Product/Process Change Notice - PCN 20_0165 Rev. -

PCN Title: Assembly Transfer of Select PBGA Products to ASE Chungli (AET)

**Assembly Transfer of Select BGA Products
to ASECL Taiwan**

225-Ball Plastic Ball Grid Array [PBGA]
(B-225-2)
Dimensions shown in millimeters

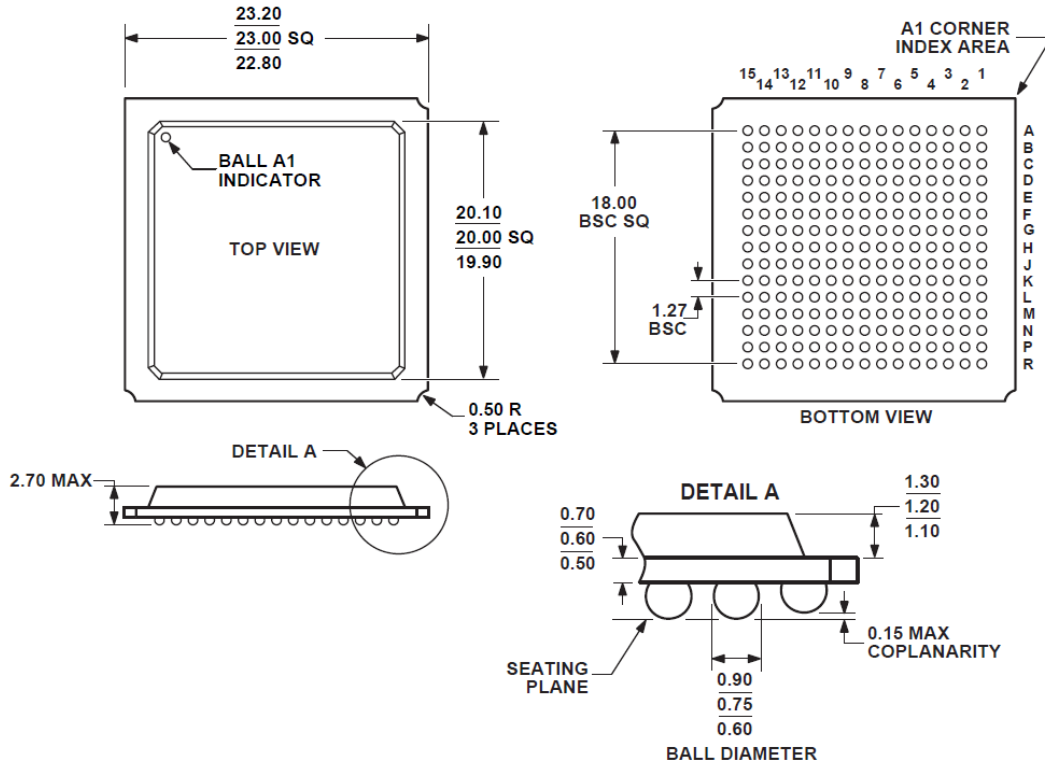
PBGA – B-225-2 (STA)
2.70mm Max Height

225-Ball Plastic Ball Grid Array [PBGA]
(B-225-3)
Dimensions shown in millimeters

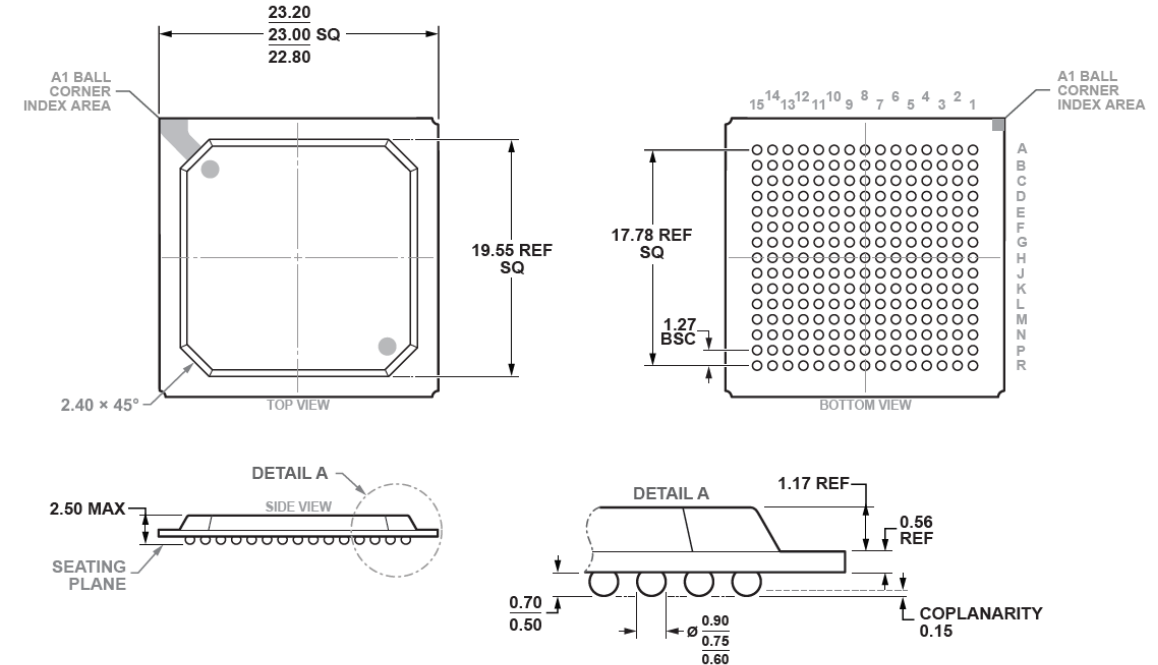
PBGA – B-225-3 (AET)
2.50mm Max Height

297-Ball Plastic Ball Grid Array [PBGA]
(B-297)
Dimensions shown in millimeters

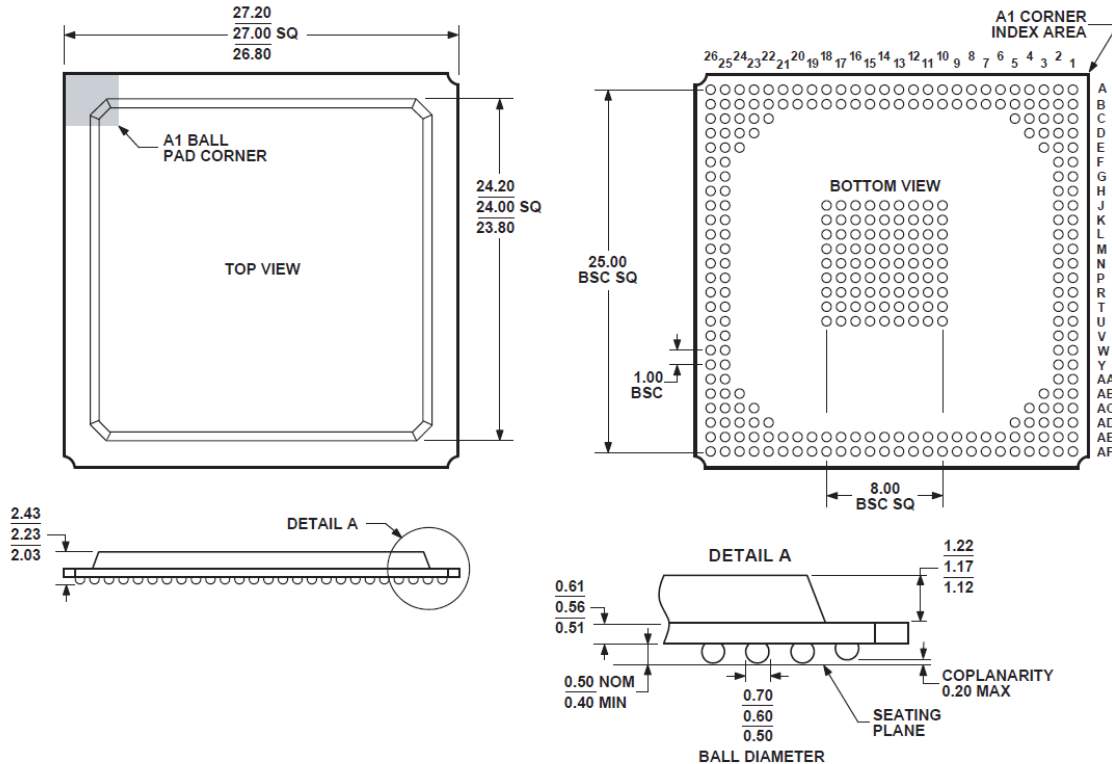
PBGA – B-297 (STA)
2.43mm Max Height

297-Ball Plastic Ball Grid Array [PBGA]
(B-297-1)
Dimensions shown in millimeters

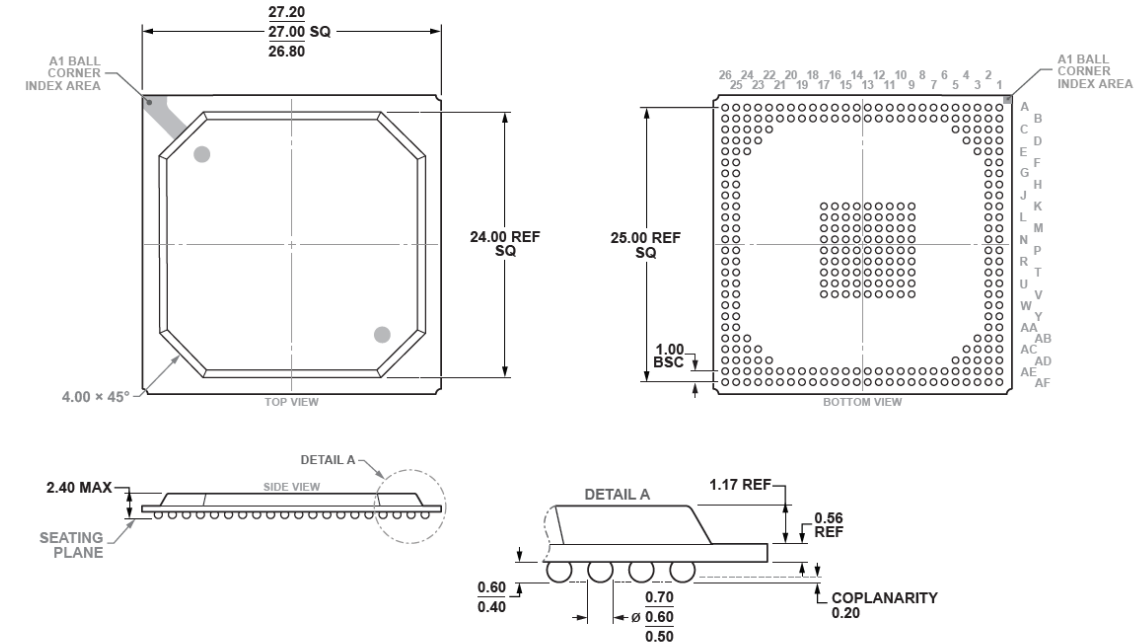
PBGA – B-297-1 (AET)
2.40mm Max Height

400-Ball Plastic Ball Grid Array [PBGA]
(B-400)
Dimensions shown in millimeters

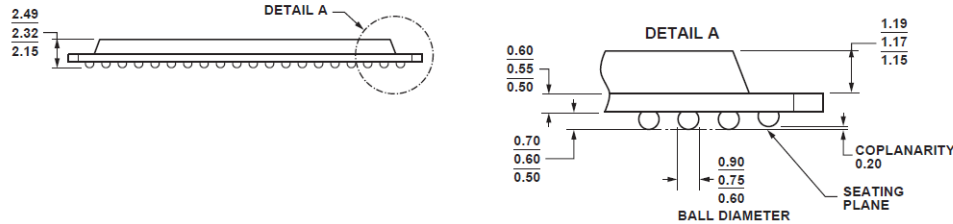
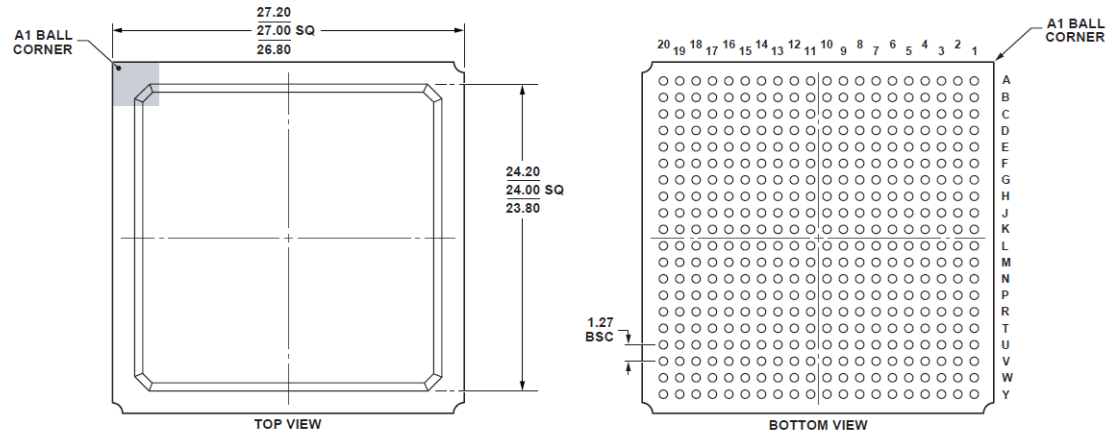
PBGA – B-400 (STA)
2.49mm Max Height

400-Ball Plastic Ball Grid Array [PBGA]
(B-400-2)
Dimensions shown in millimeters

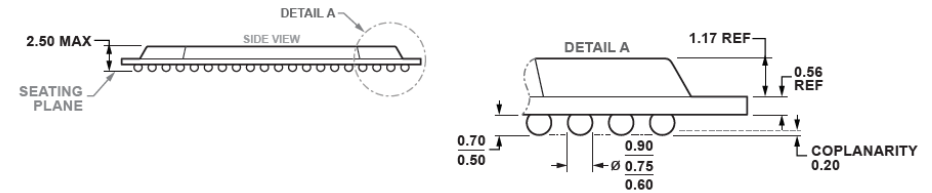
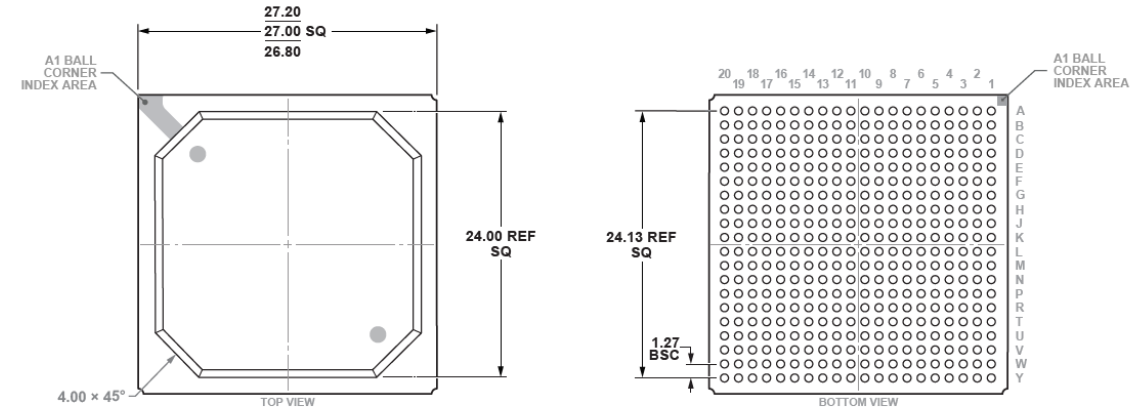
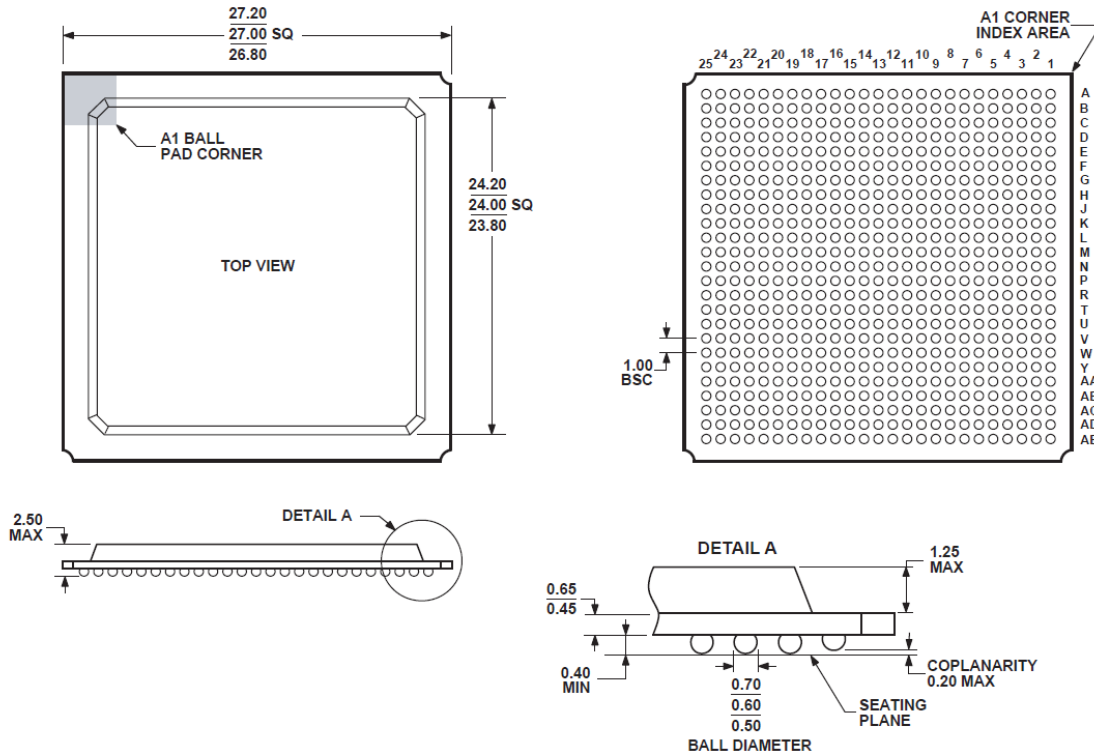
PBGA – B-400-2 (AET)
2.50mm Max Height

625-Ball Plastic Ball Grid Array [PBGA]
(B-625-2)
Dimensions shown in millimeters

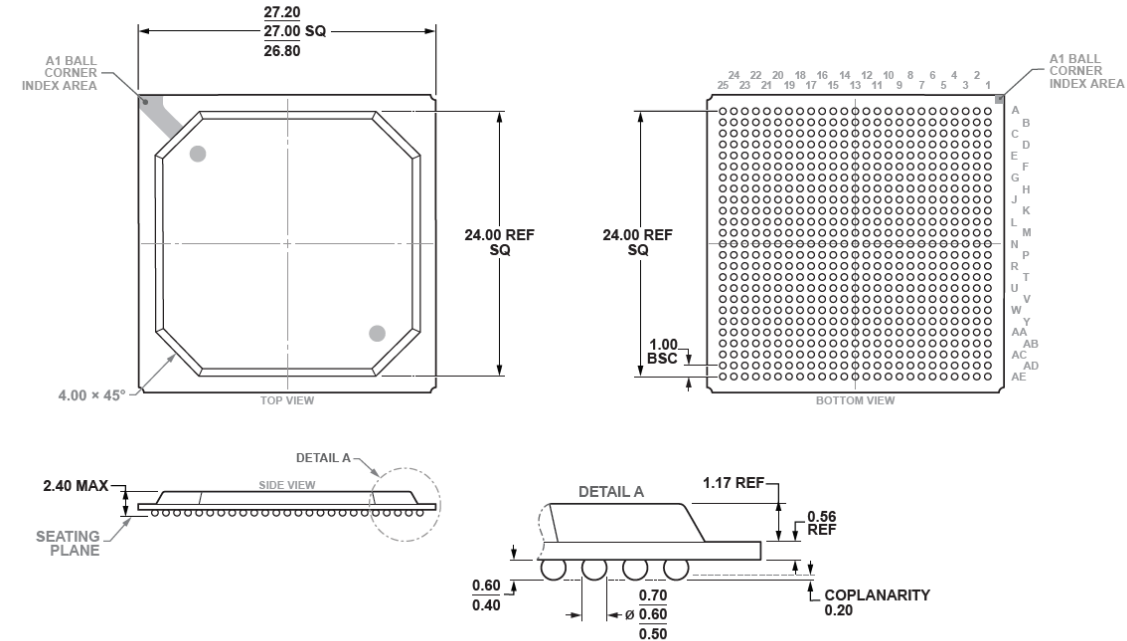
PBGA – B-625-2 (AET)
2.40mm Max Height
